1445 NEW YORK AVENUE NW

PROPOSED RENOVATIONS

COMMISSION OF FINE ARTS

CONCEPT REVIEW SUBMISSION

PATINA STUDY

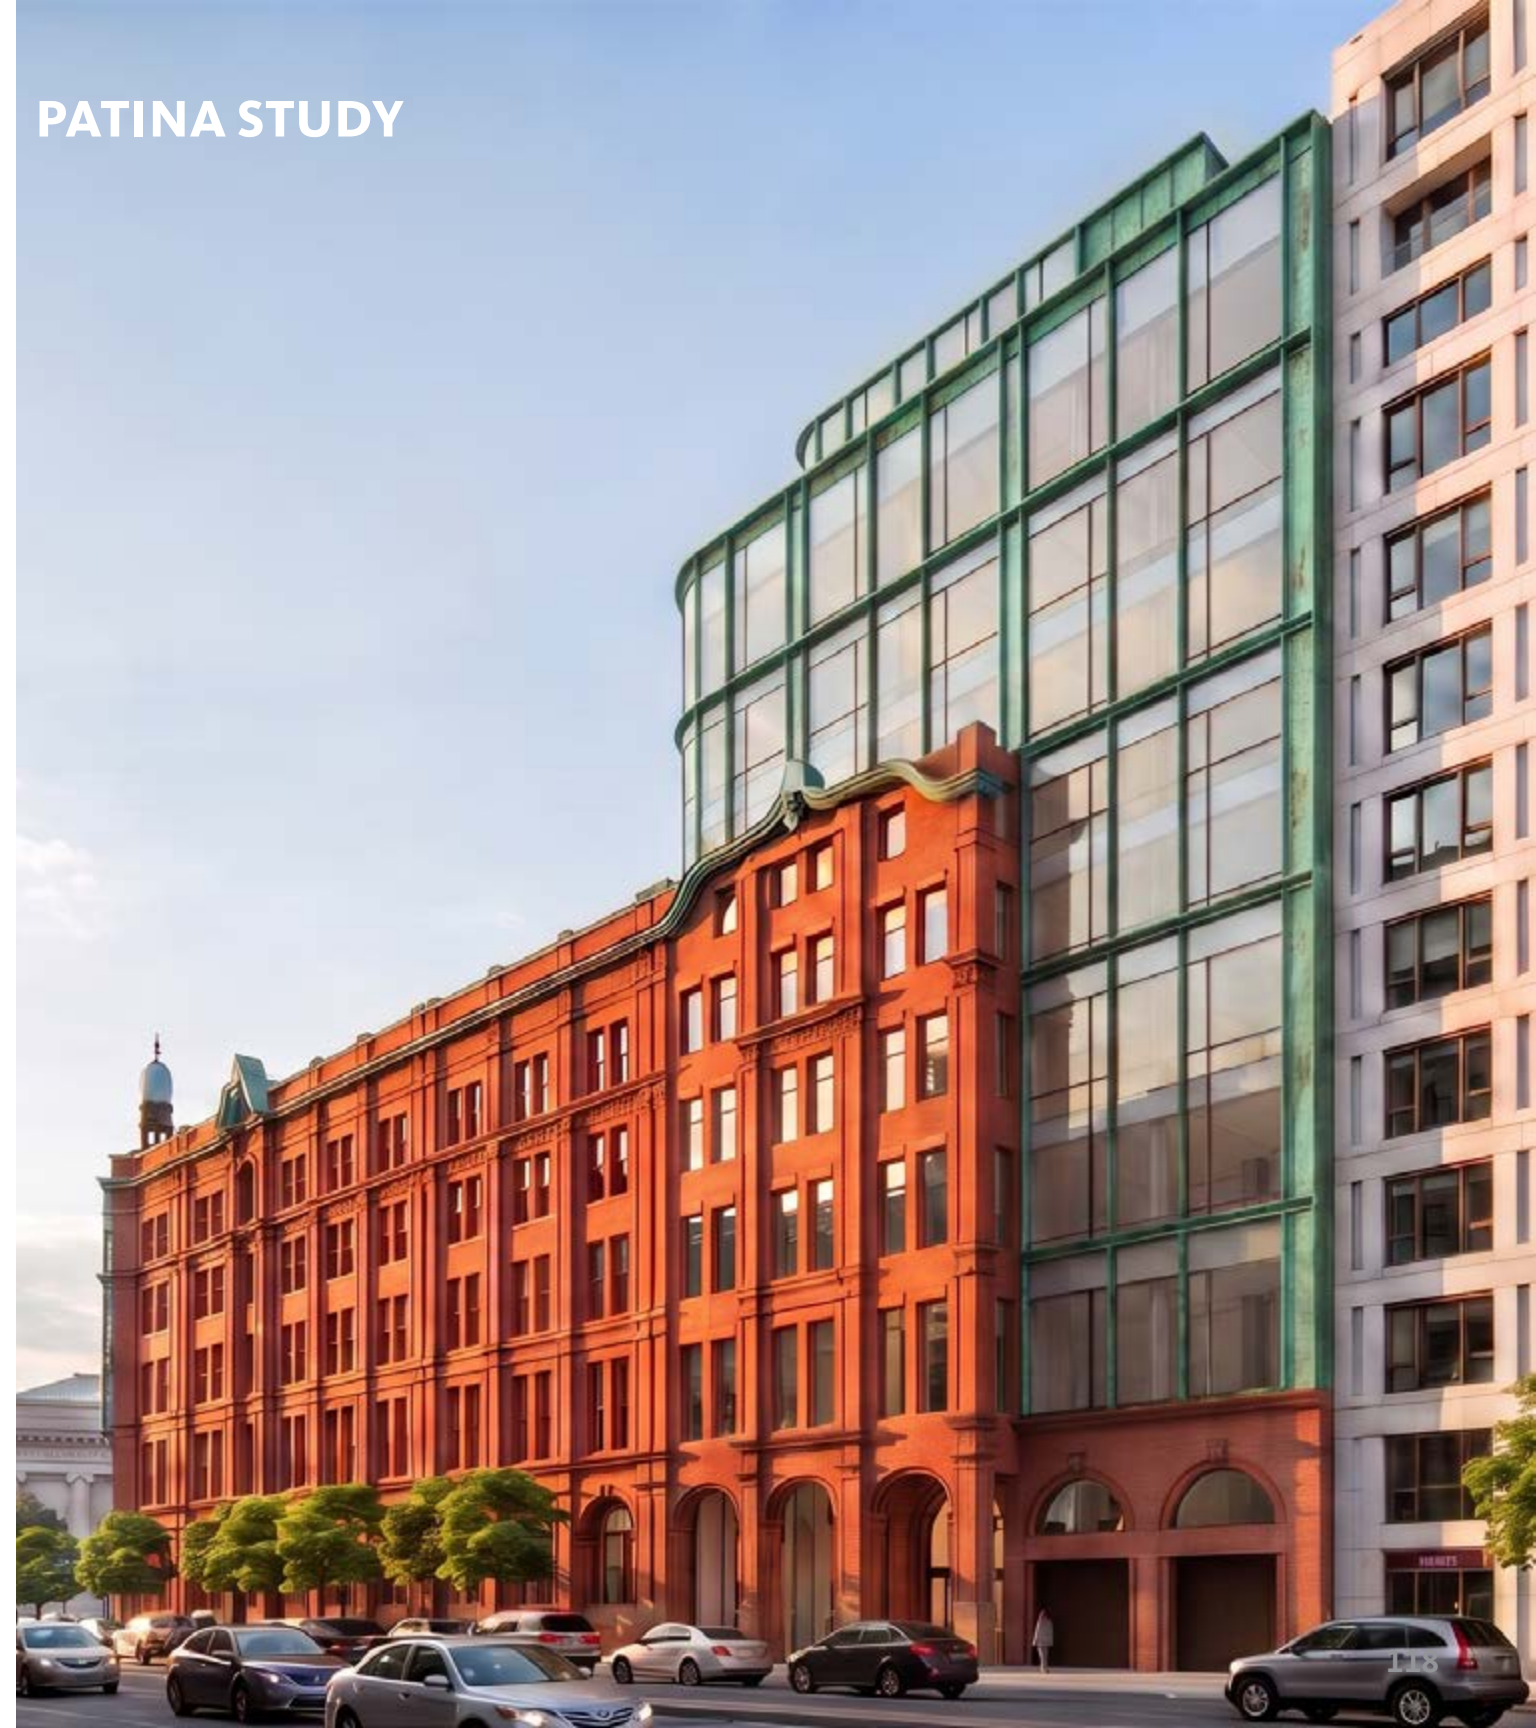
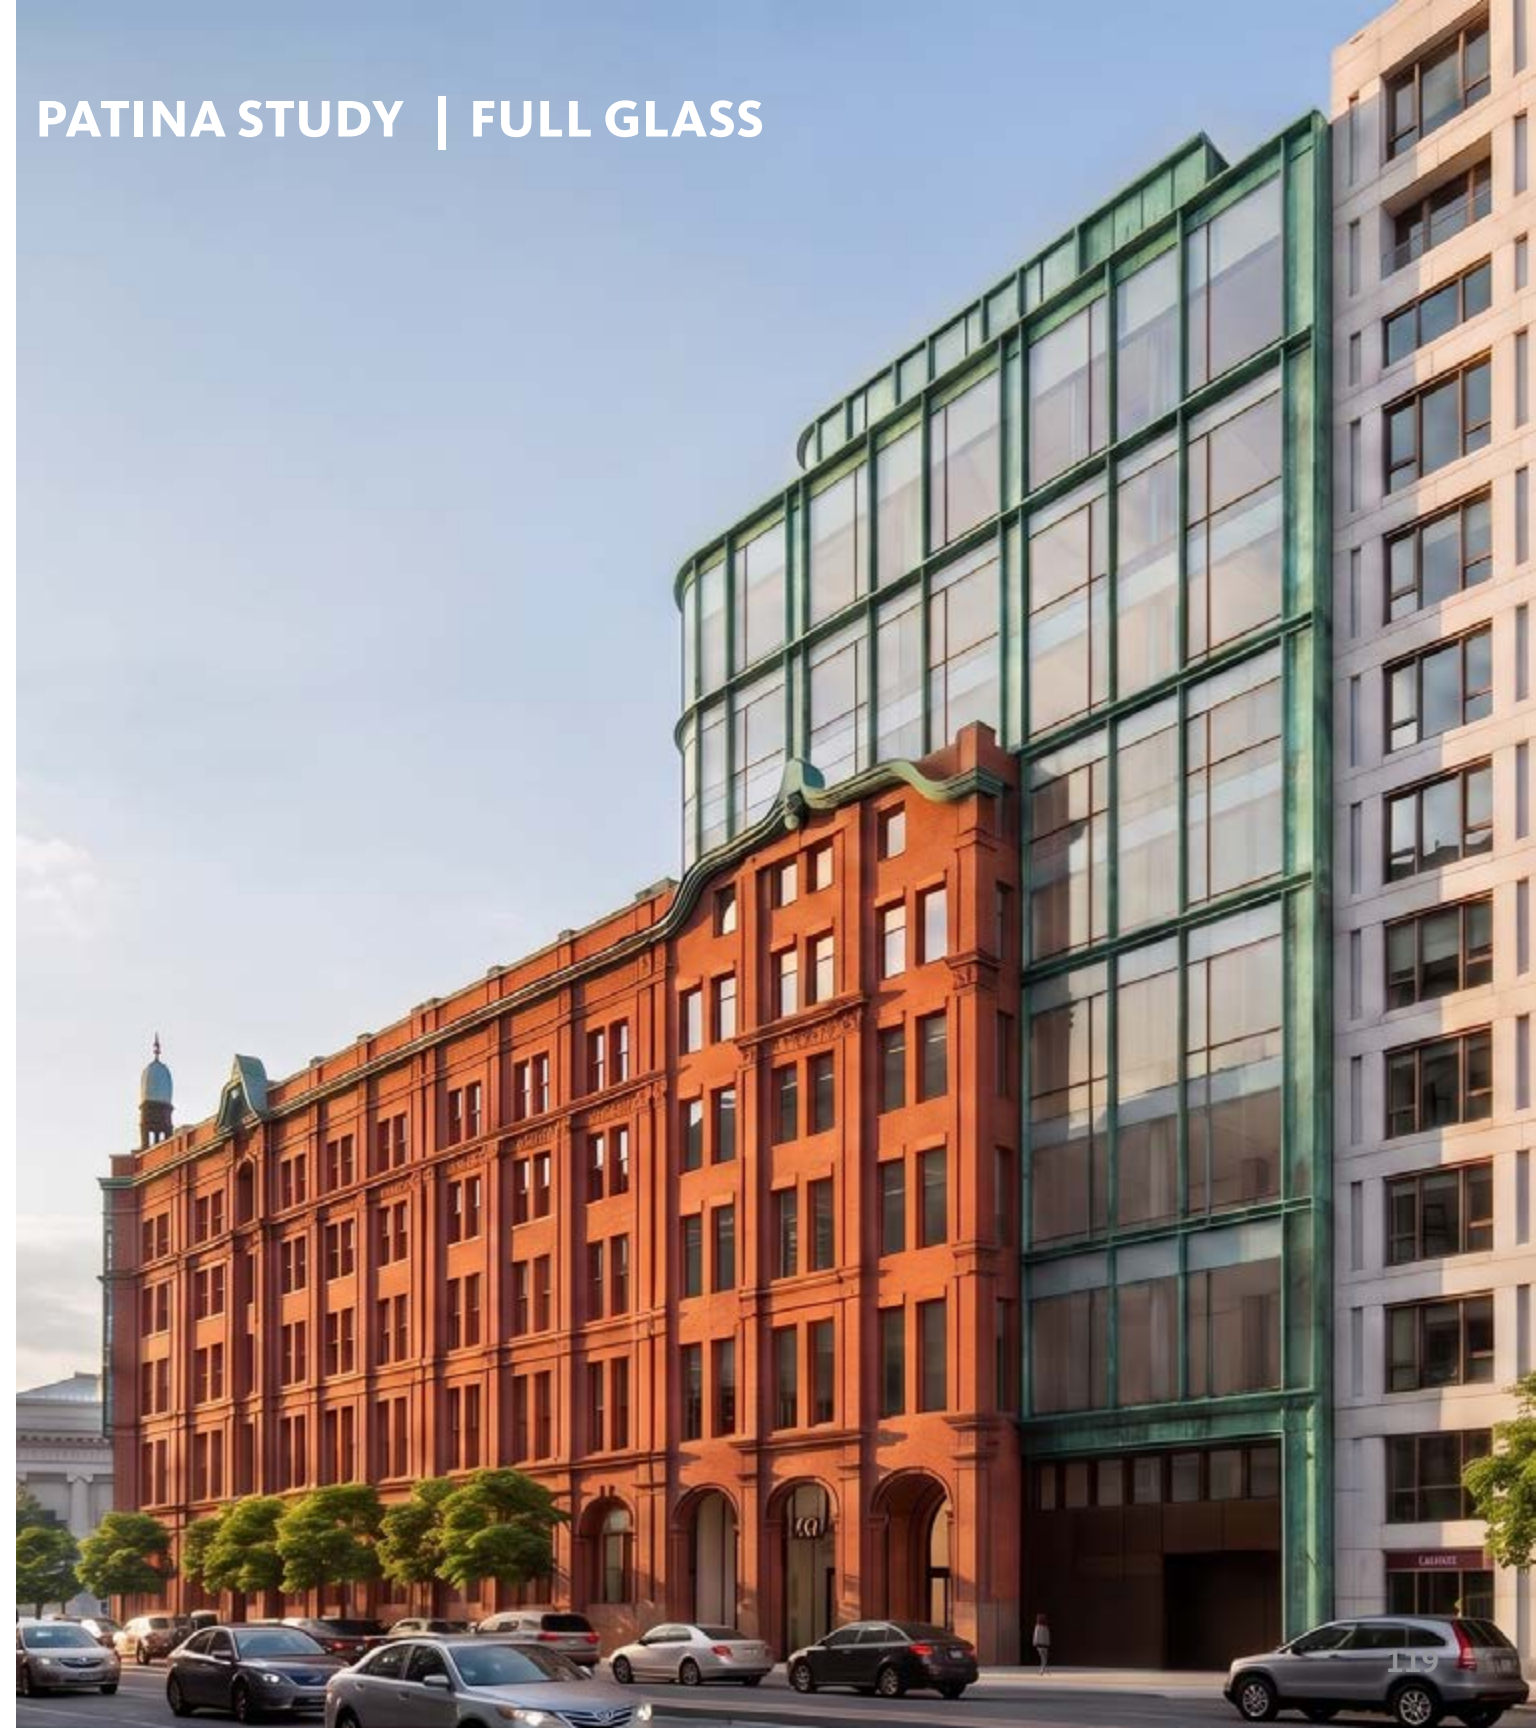
Study patina copper option for metal
